FLYING HORSE NORTH FILING NO. 3
CONSTRUCTION DOCUMENTS

AS-BUILT VERSION 1.0, DATED 7/15/2026
PE: RICHARD LYON
CO PE NO. 53921

FLYING HORSE NORTH FILING 3
PRI #2, LLC.
EL PASO COUNTY, CO

SHEET
CV
1

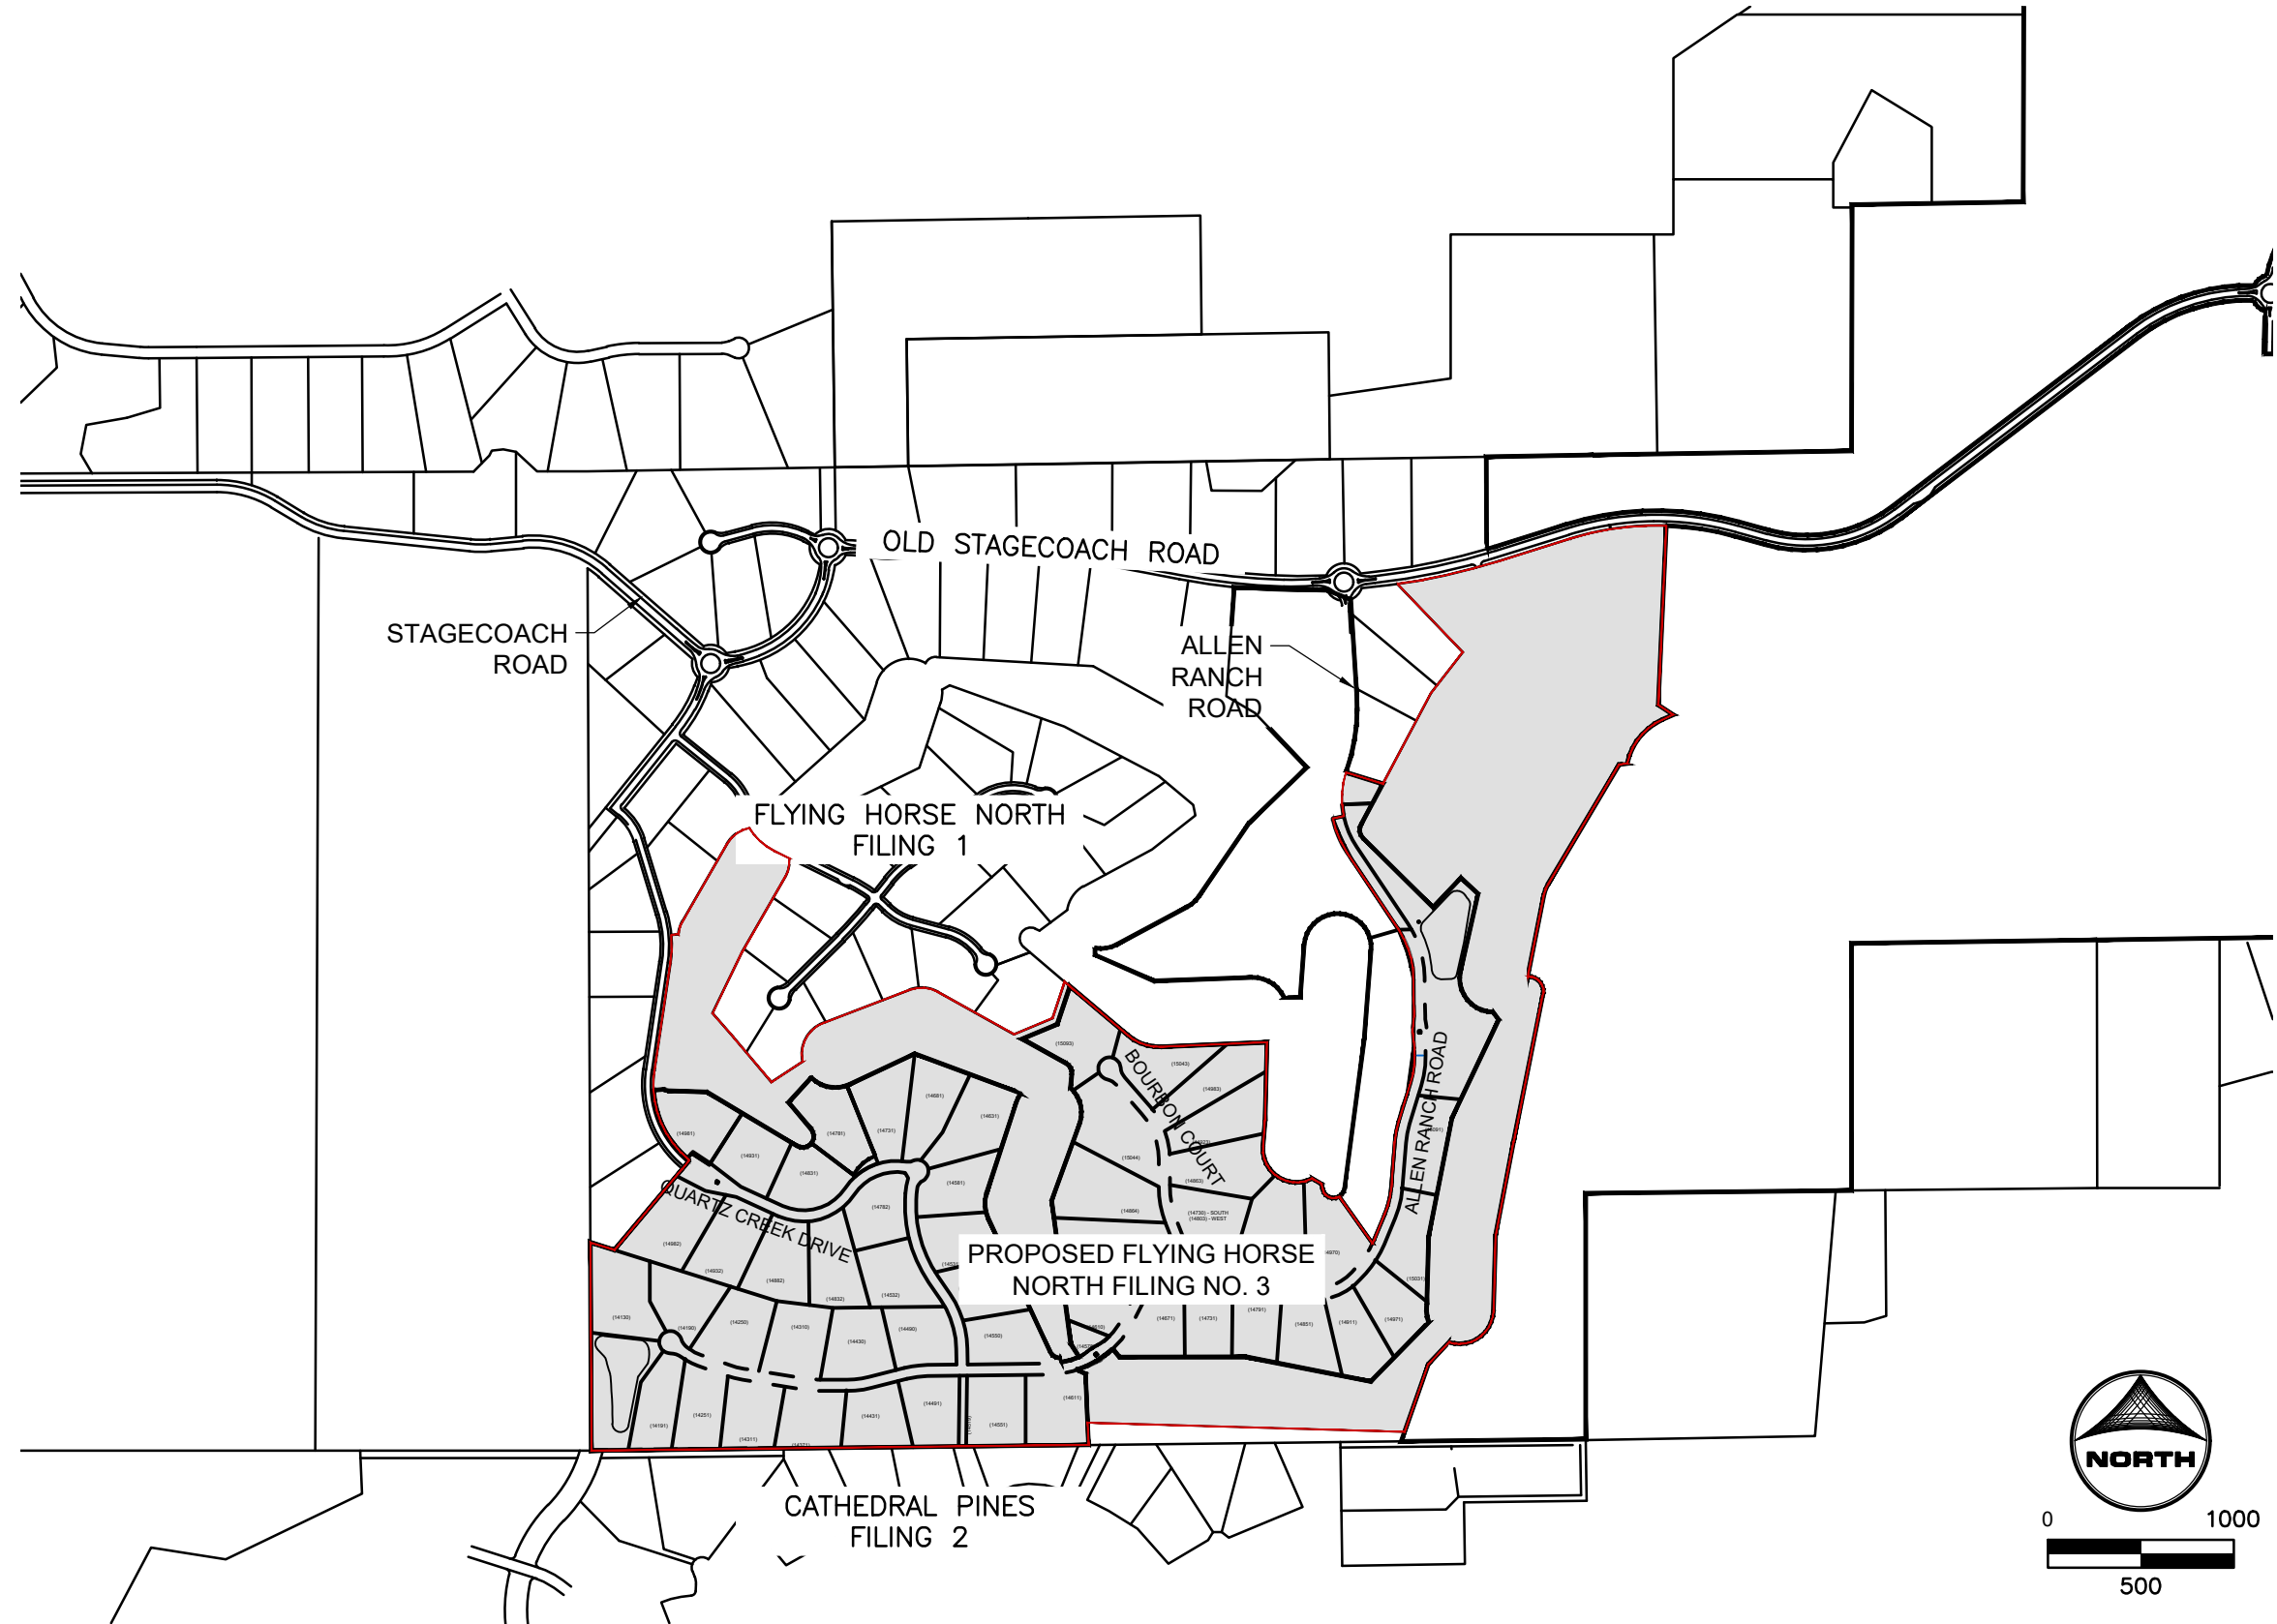
Per ECM 5.10.6, label each sheet as "As-Built" or "Engineer Record Drawings" with EOR stamp and signature.

SHEET
ST 12

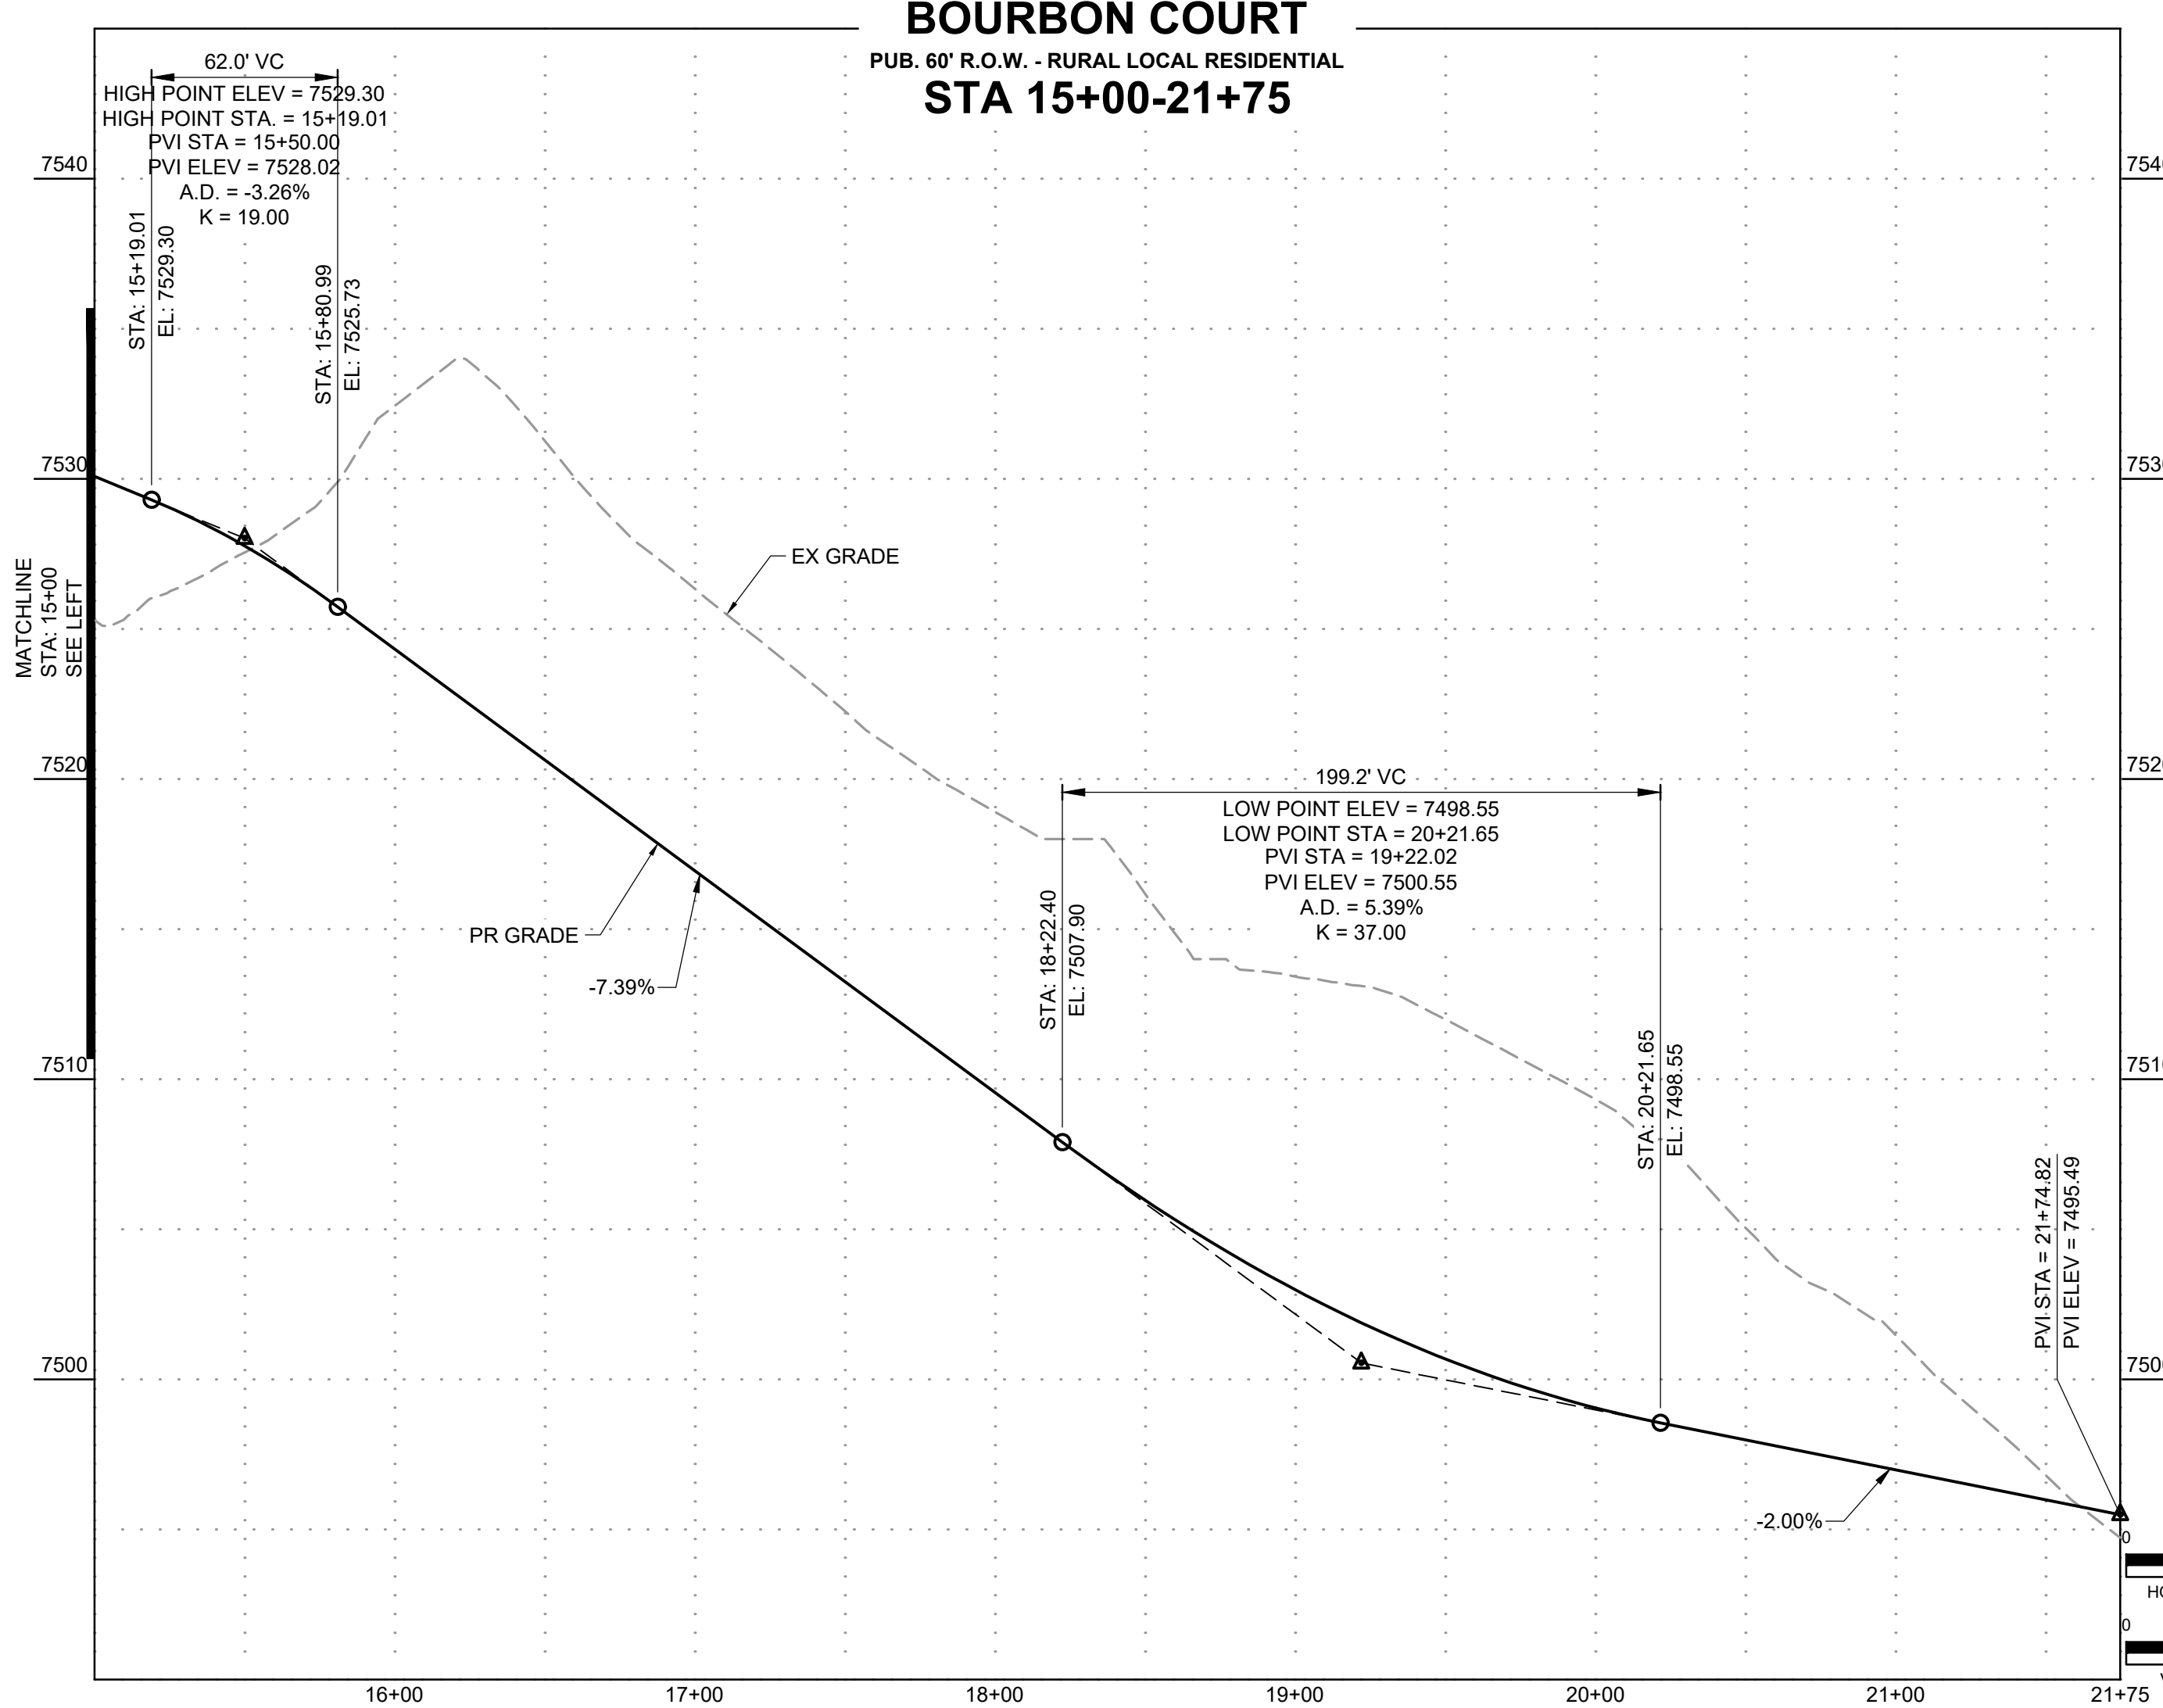
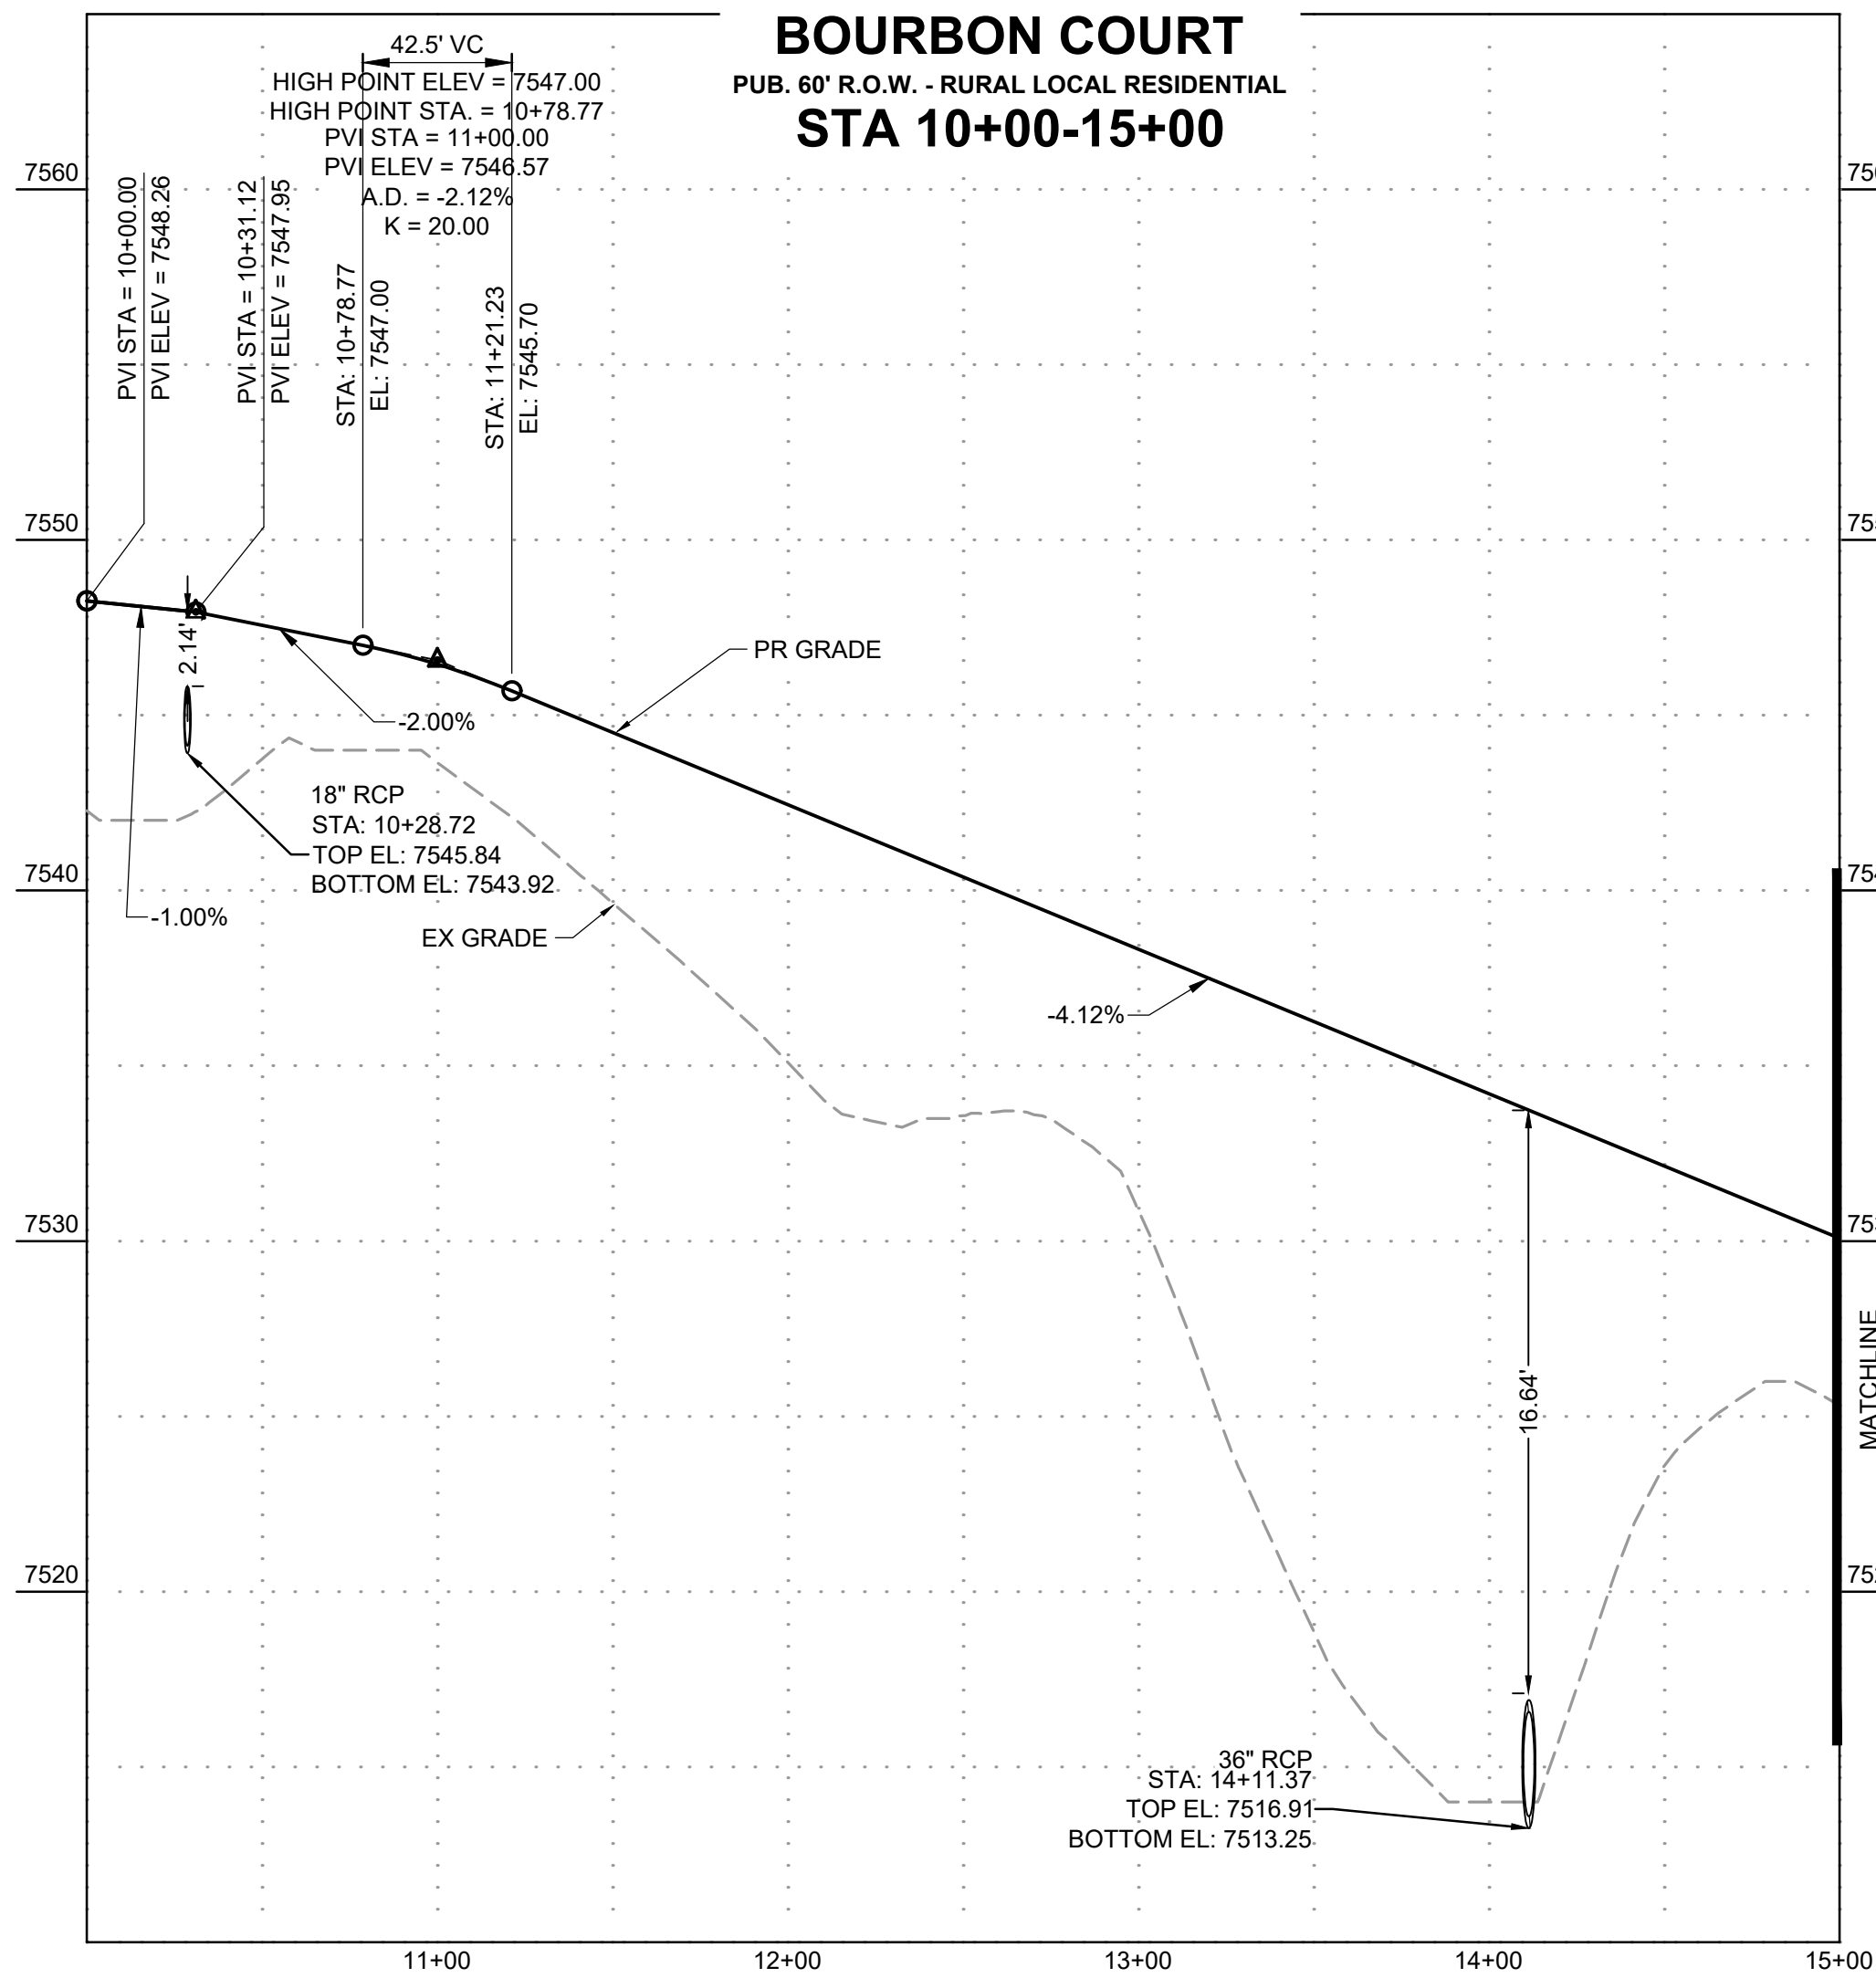
AS-BUILT VERSION 1.0, DATED 7/15/2026
PE: RICHARD LYON
CO PE NO. 53921
SHEET 12:
- TYPICAL ALL SHEETS WHERE
APPLICABLE: EXPOSED RIP-RAP
AT CULVERT PIPES TO BE BURIED
SOIL RIP-RAP WITH 4" TOPSOIL.
